# CREEKSIDE SOUTH AT LORSON RANCH PUD Development & Preliminary Plan

REV.#	REVISIONS	DATE
1	1ST COMMENT RESPONSE	5.8.20
2		
3		
4		
5		
6

## COVER SHEET

PCD FILE NO.: PUDSP-20-001

SITE PLAN  
P5 5 OF 10

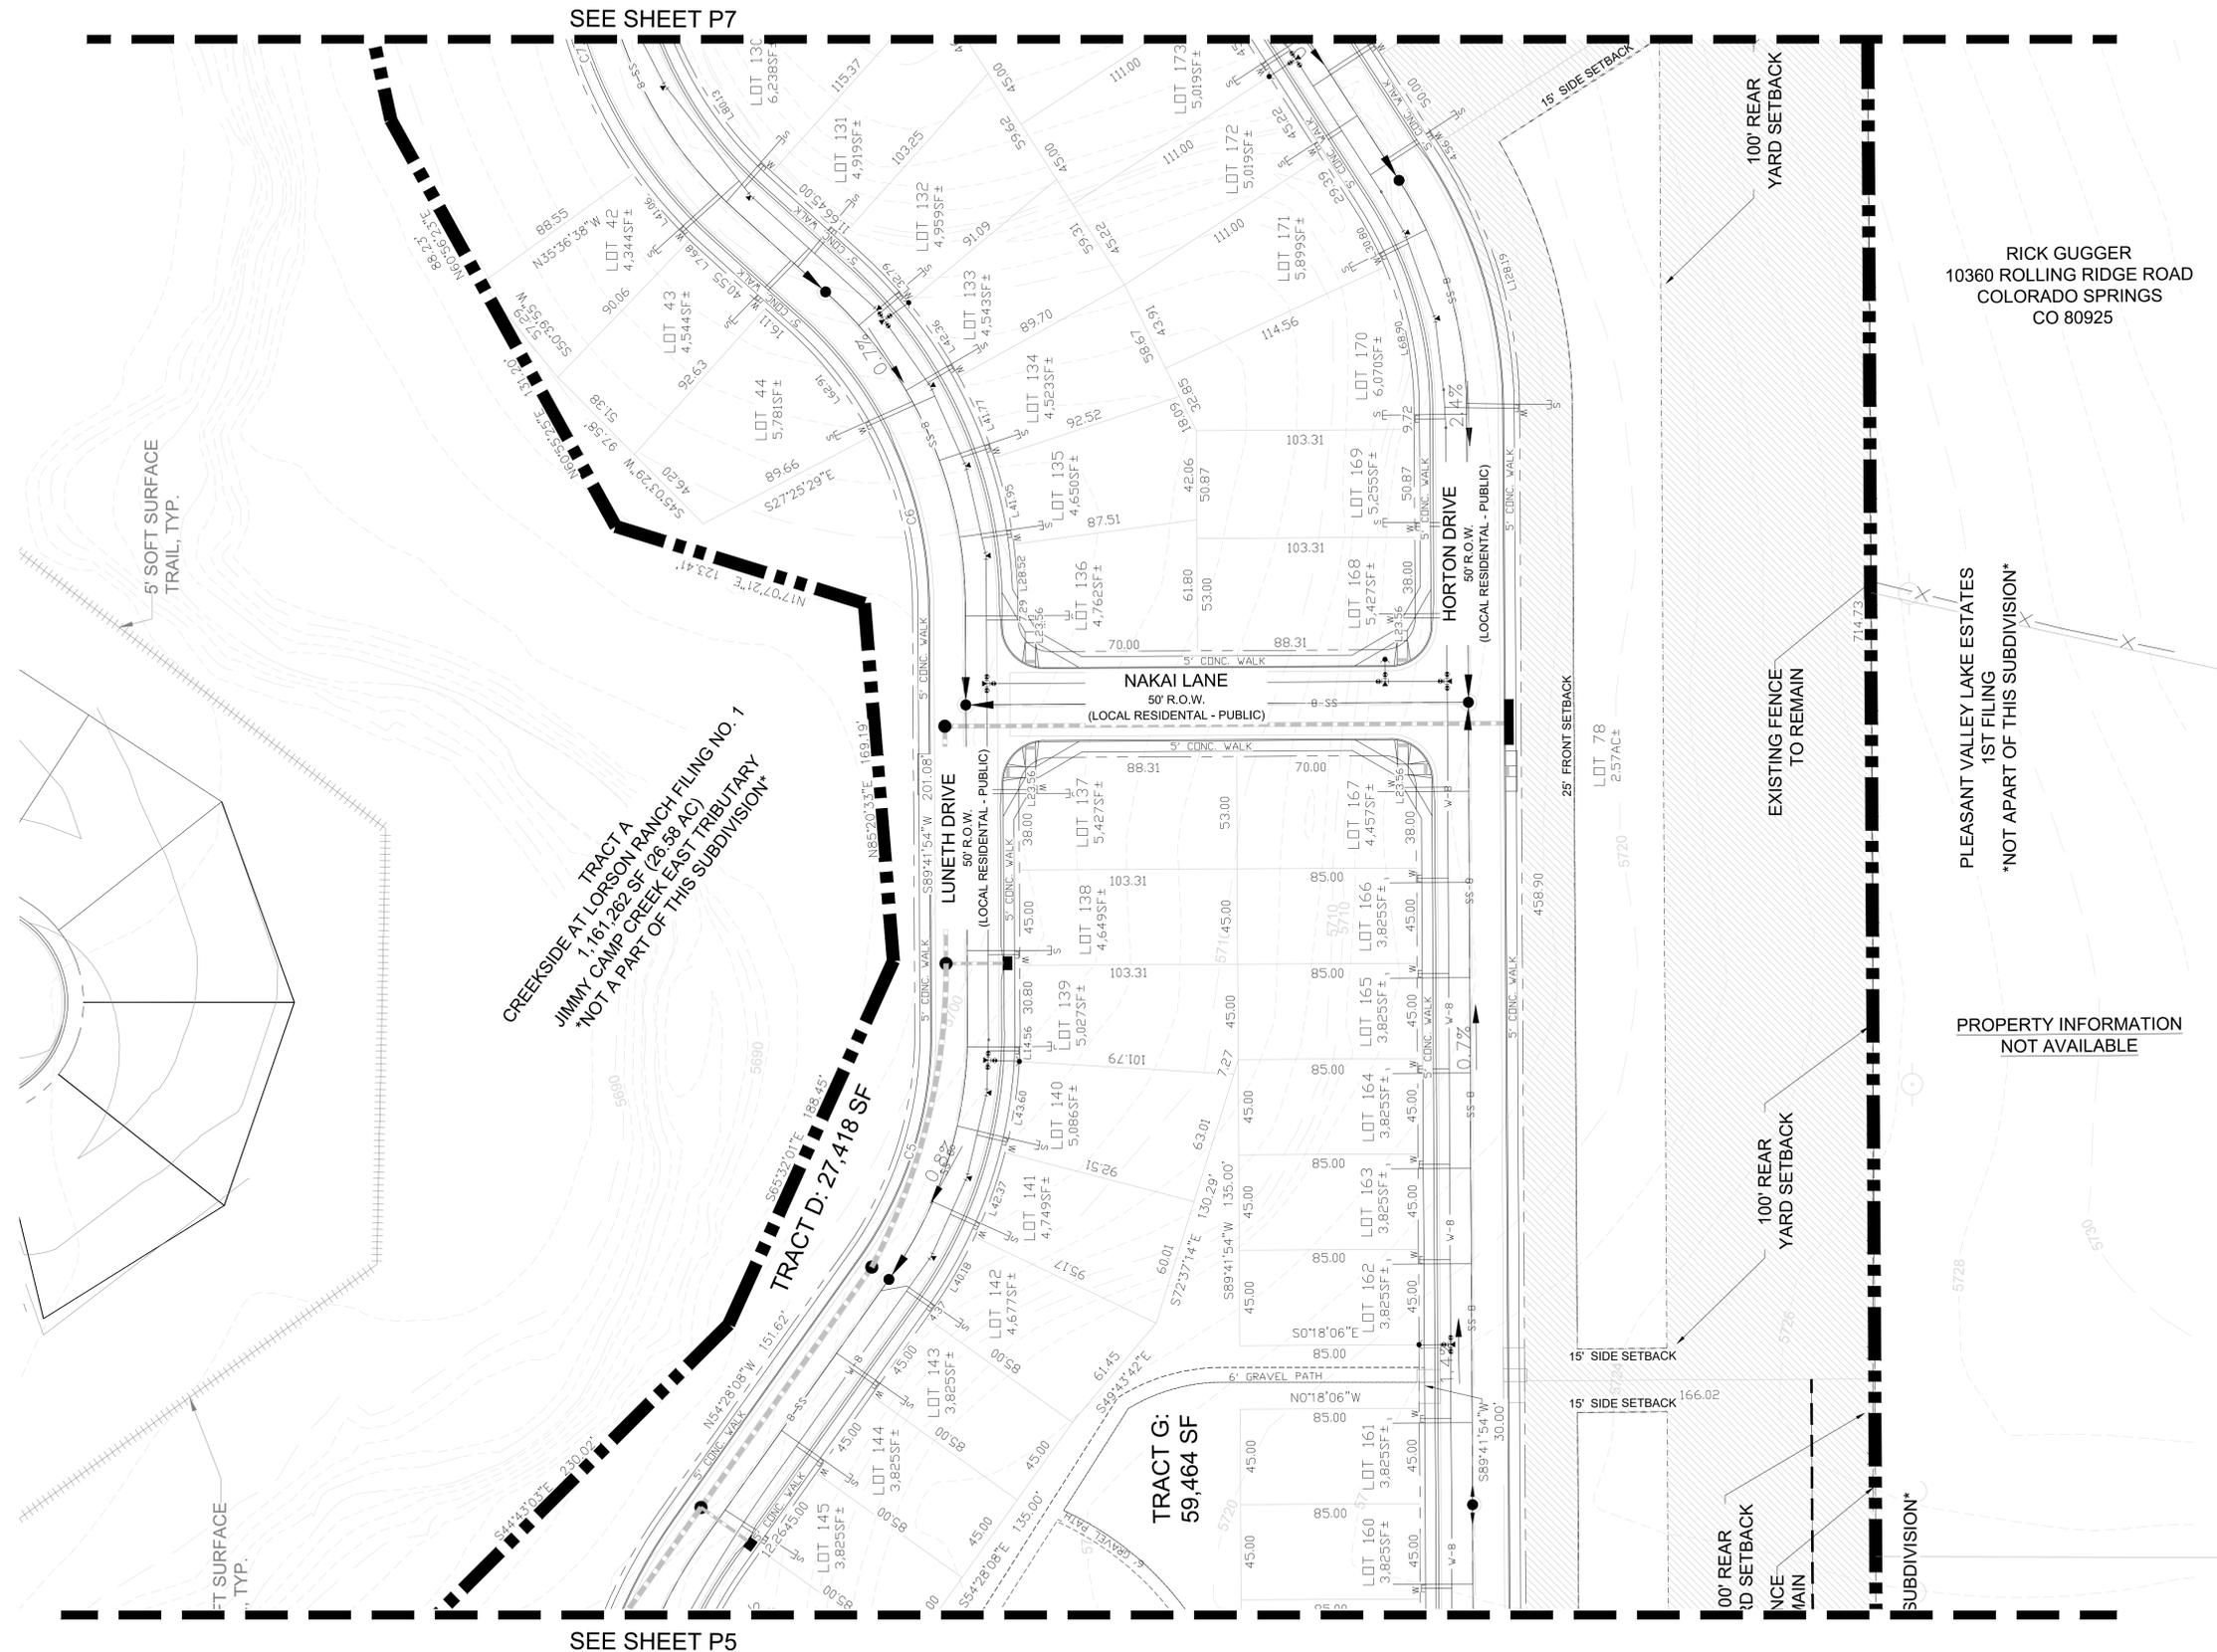
Show and label the FEMA 100-year floodplain (all sheets).

Show and label FSD outline and label Pond J.

SITE PLAN  
P6 6 OF 10

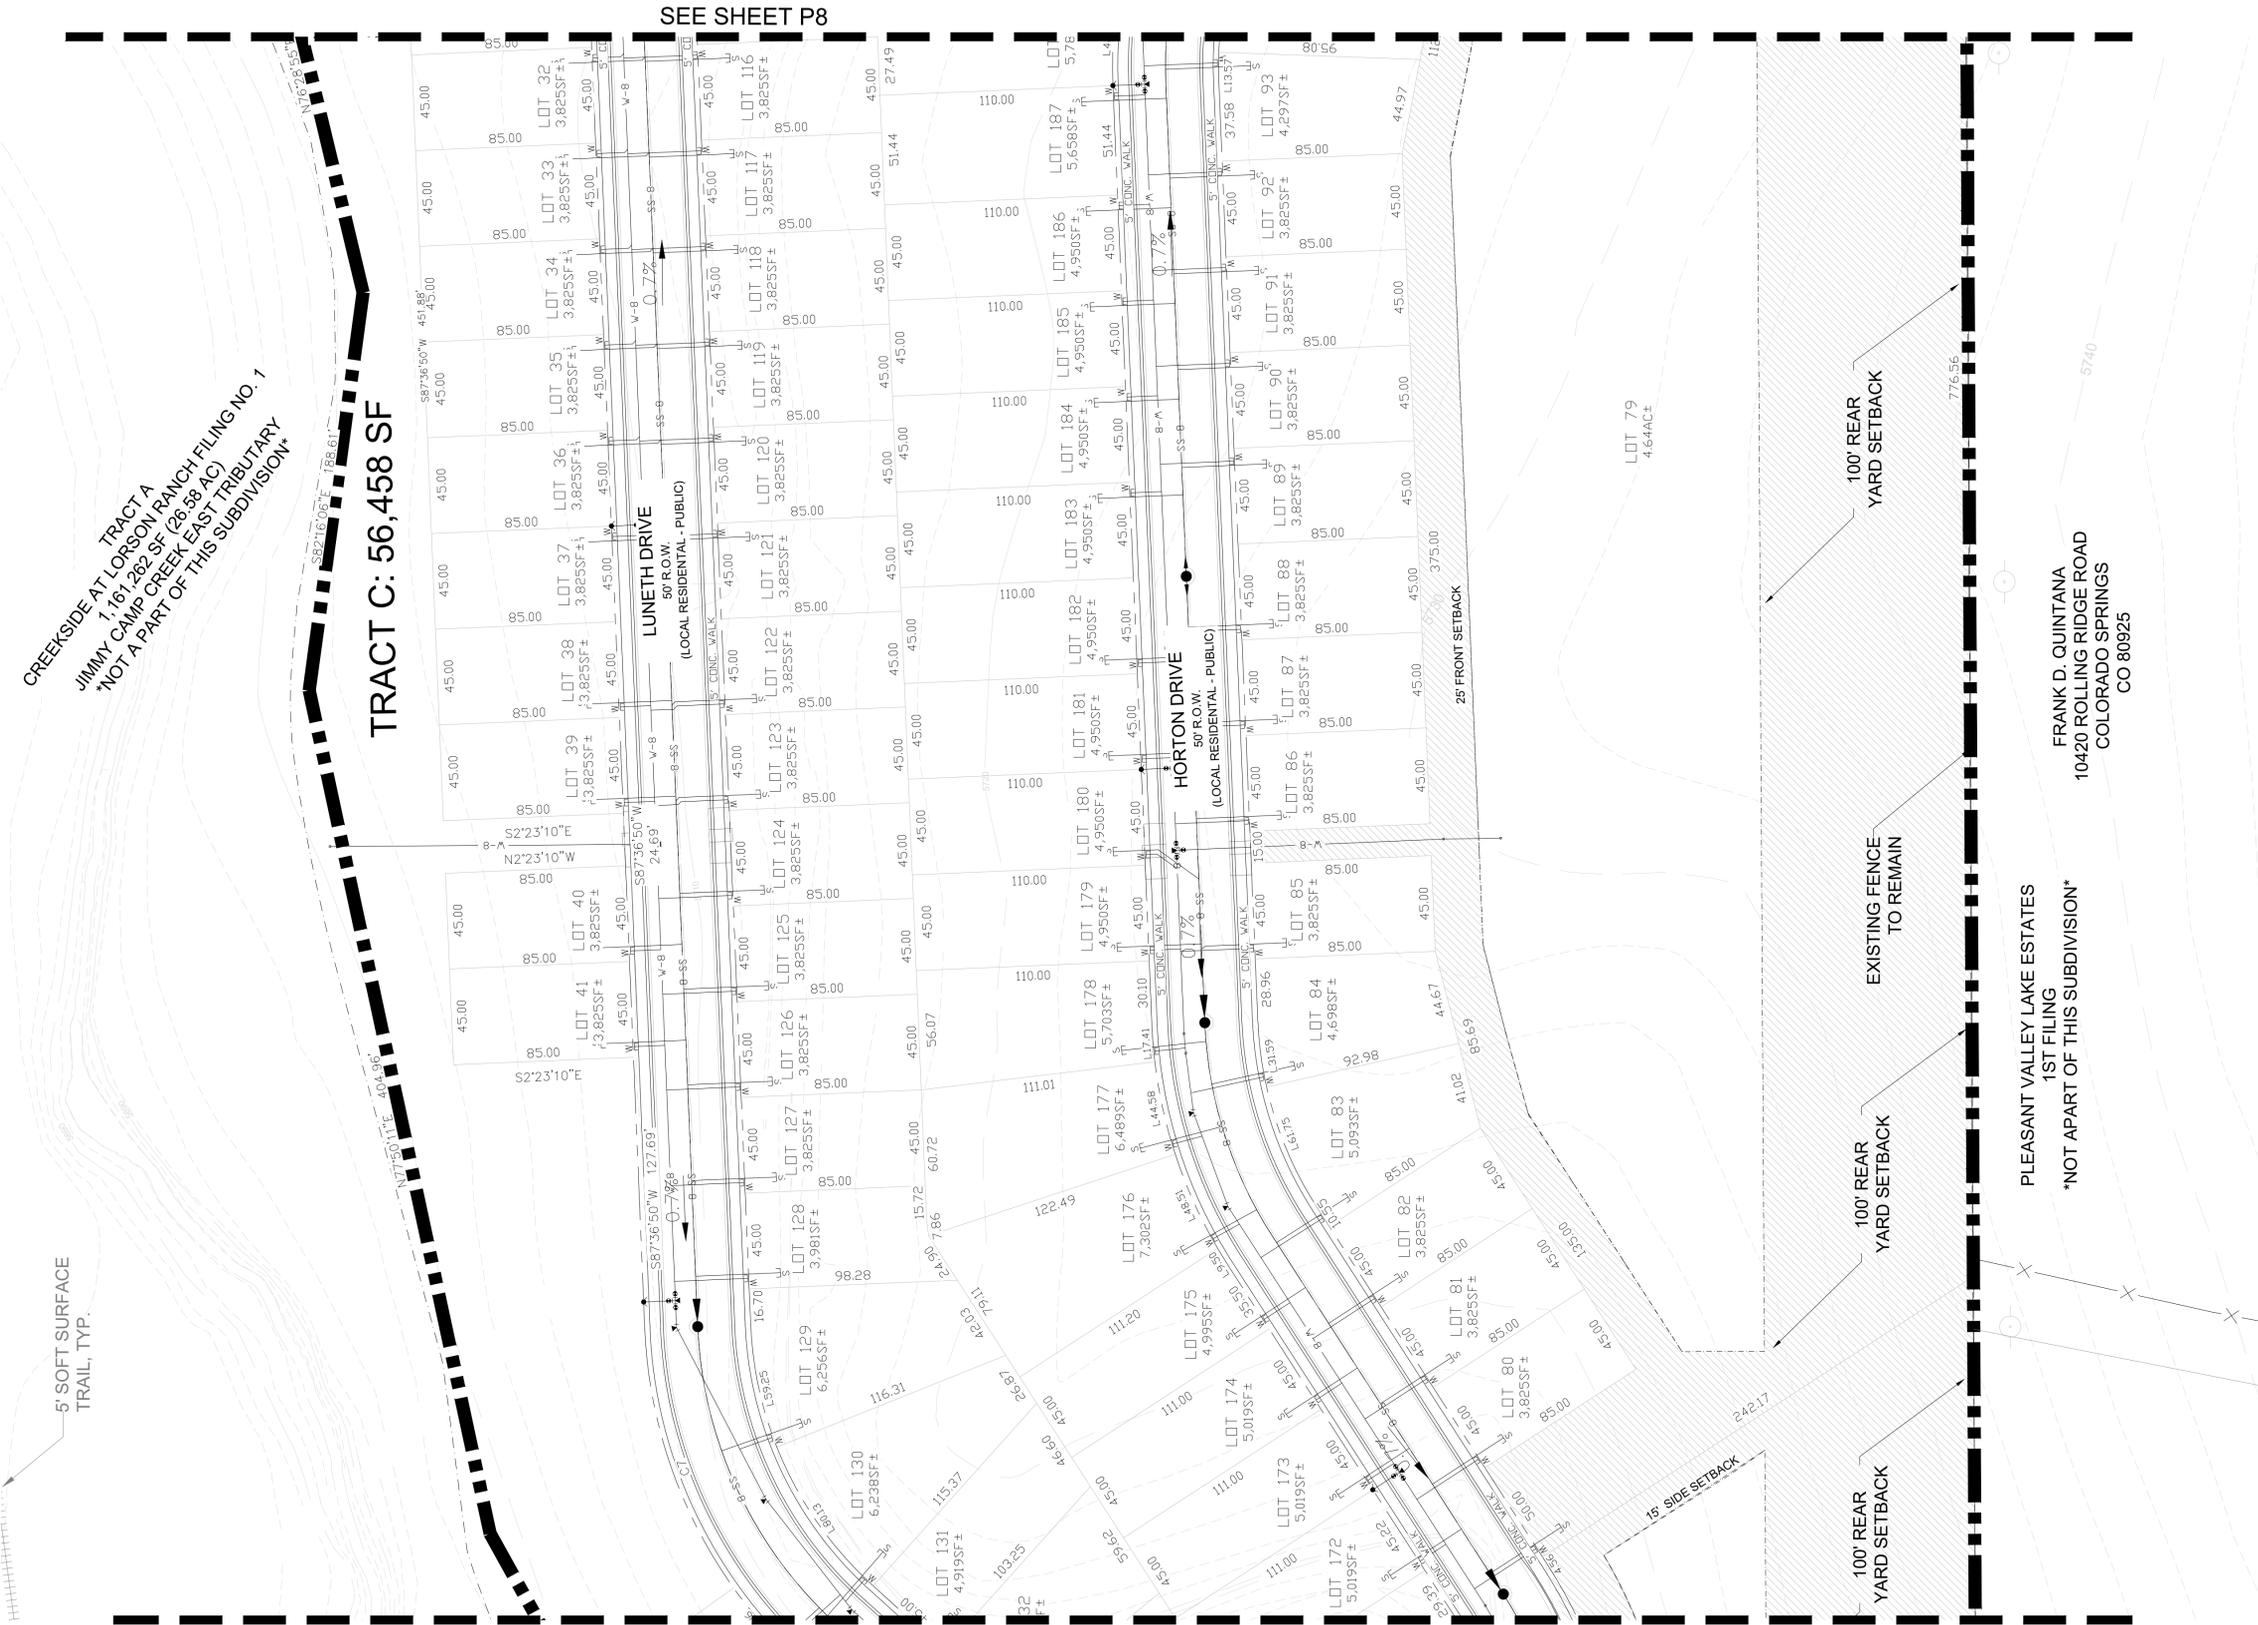
this hatch = drainage easement, no build

Hatch + setback area

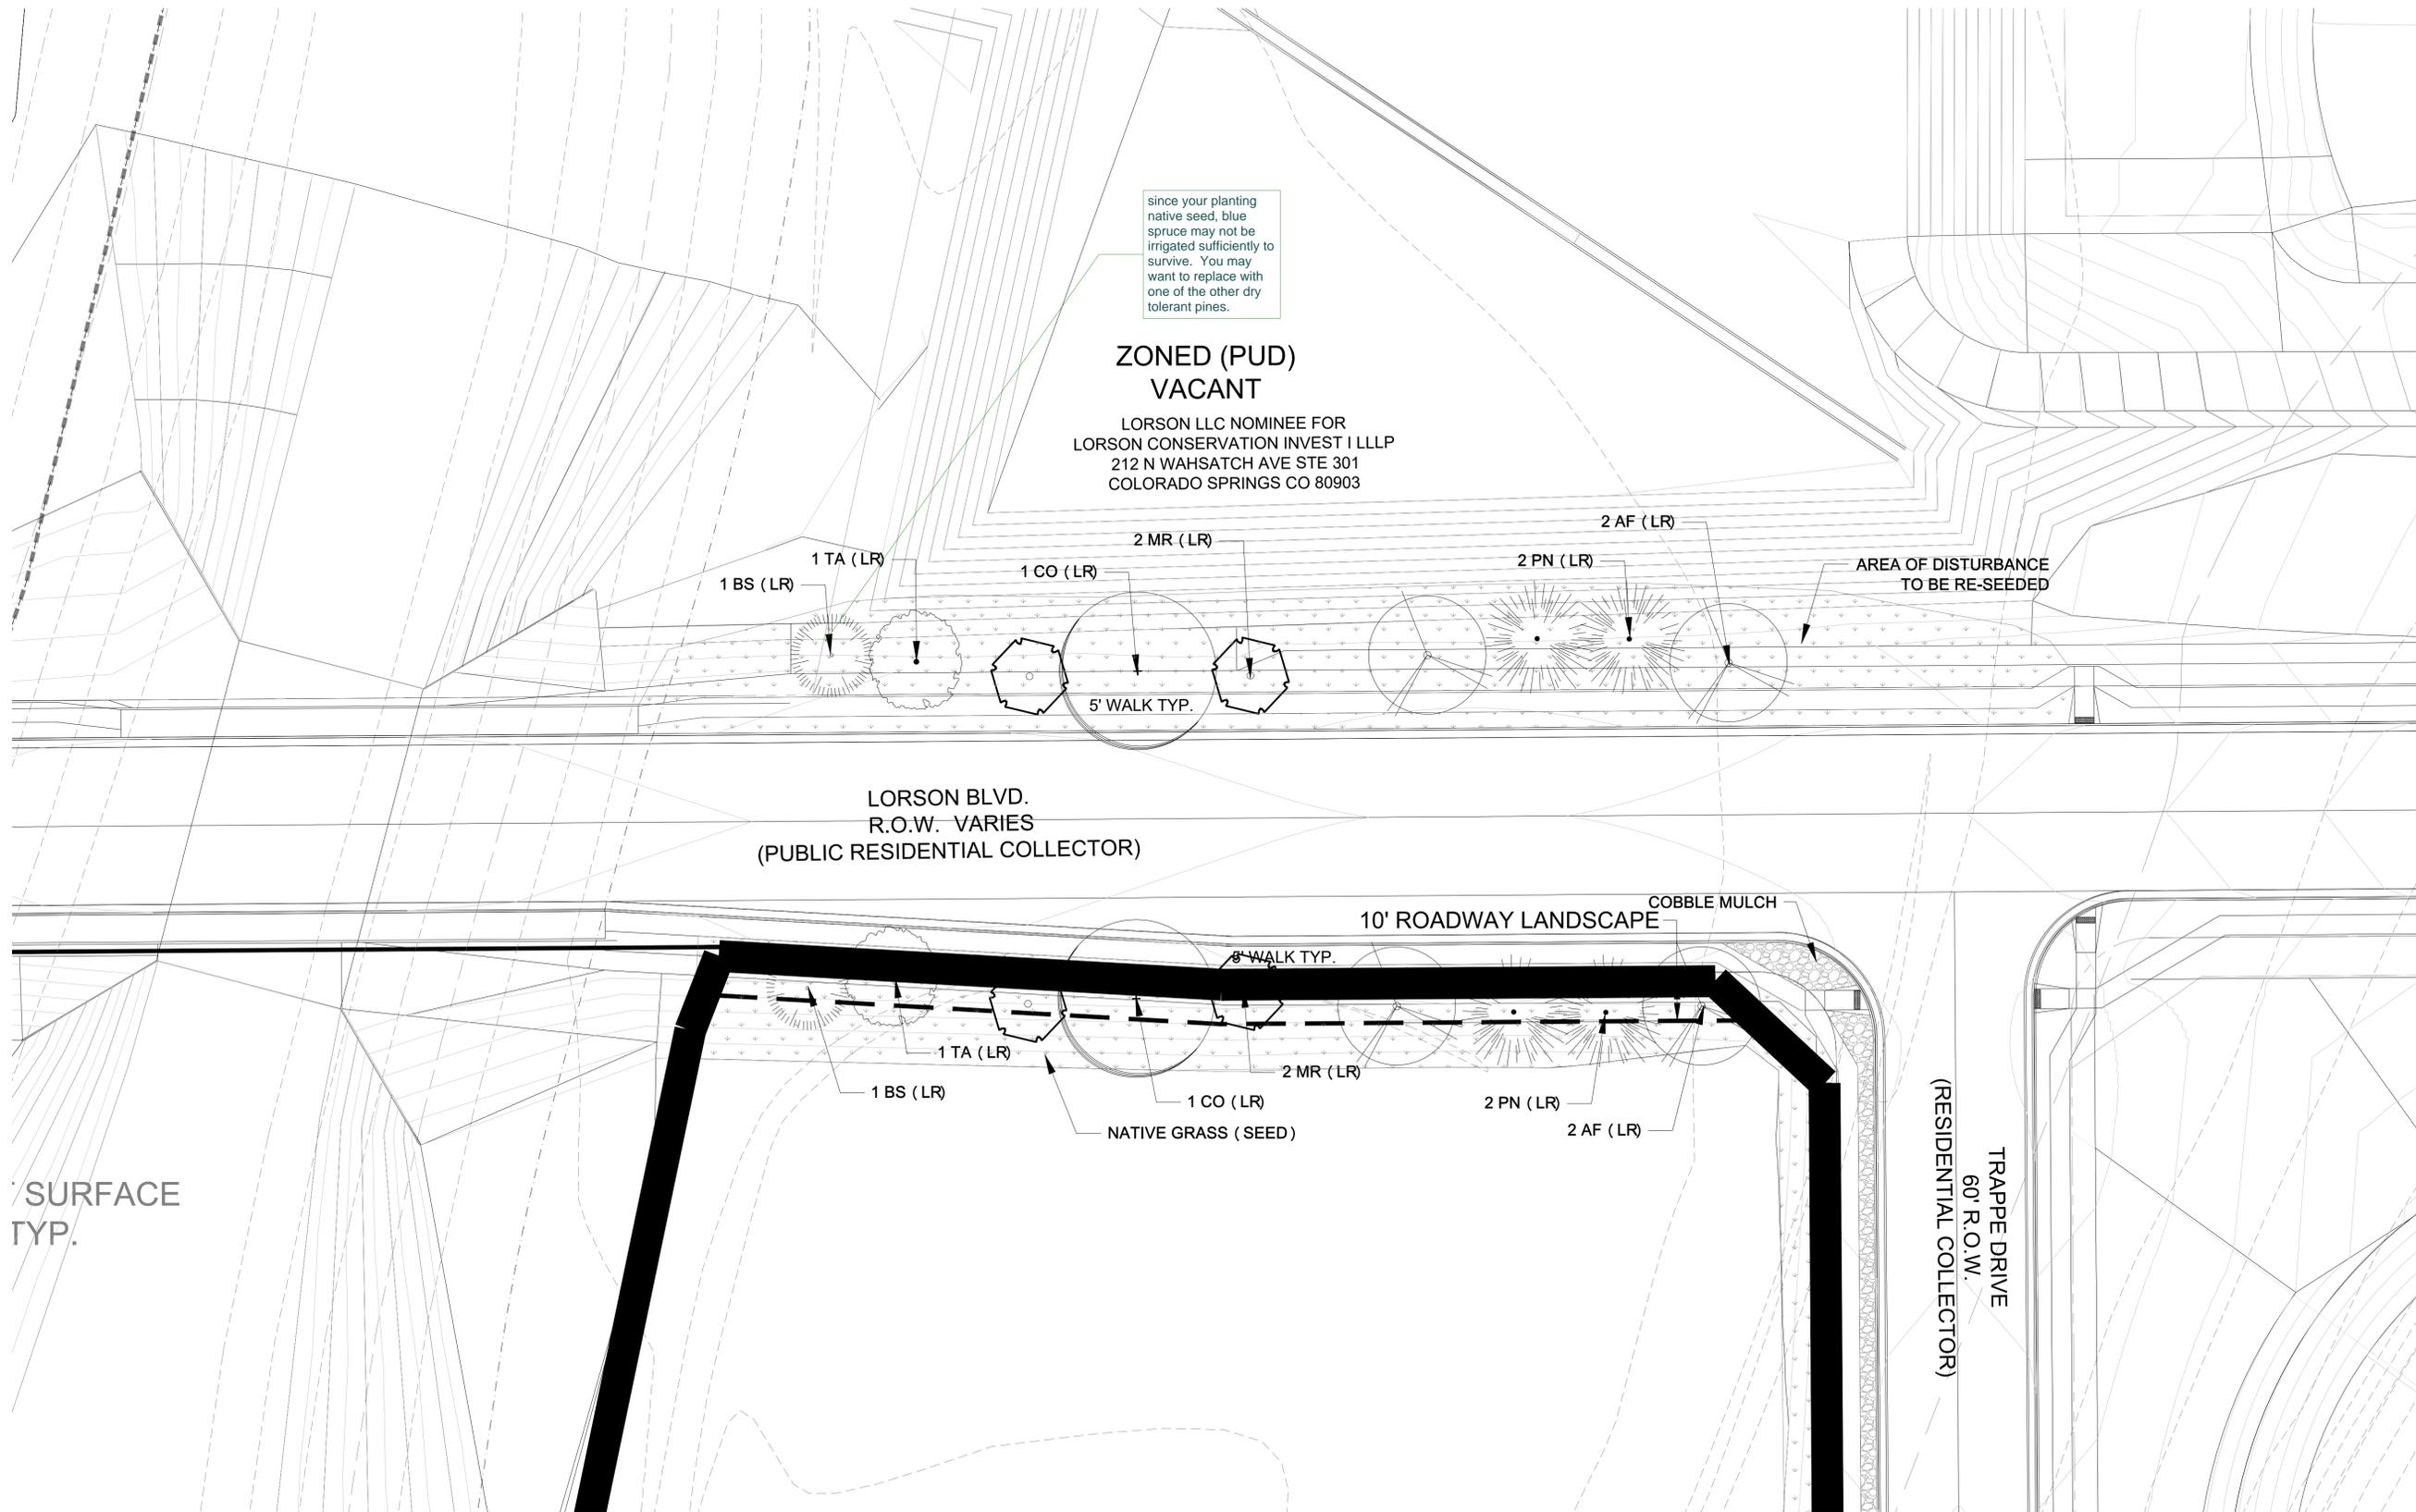
since your planting native seed, blue spruce may not be irrigated sufficiently to survive. You may want to replace with one of the other dry tolerant pines.
